[Docket No. FAA-2016-4674; Directorate Identifier 2016-SW-001-AD; Amendment 39-18835; AD 2017-06-11]

Airworthiness Directives; Airbus Helicopters

ACTION: Final rule; request for comments.

Figure 1 to paragraph (f)(1)(ii)

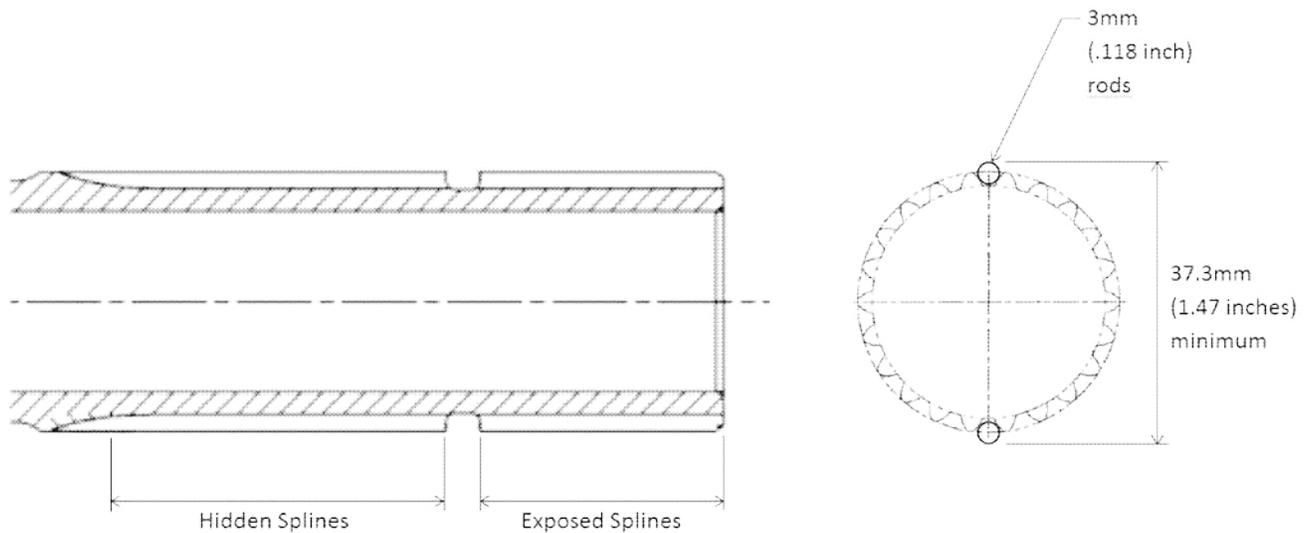
(ii) Inspect the exposed portion of each wheel spline for cracking, scoring, metal pick-up, and wear by using Figure 1 to paragraph (f)(1)(ii) of this AD. To inspect for wear, position two 3 mm

(0.118 inch) rods in all diametrically opposed splines and measure to determine whether there is a minimum of 37.3 mm (1.47 inches) across the outside diameter of the rods. If there is any cracking, scoring or metal pick-up, or if a measurement is less than 37.3 mm, replace the wheel.
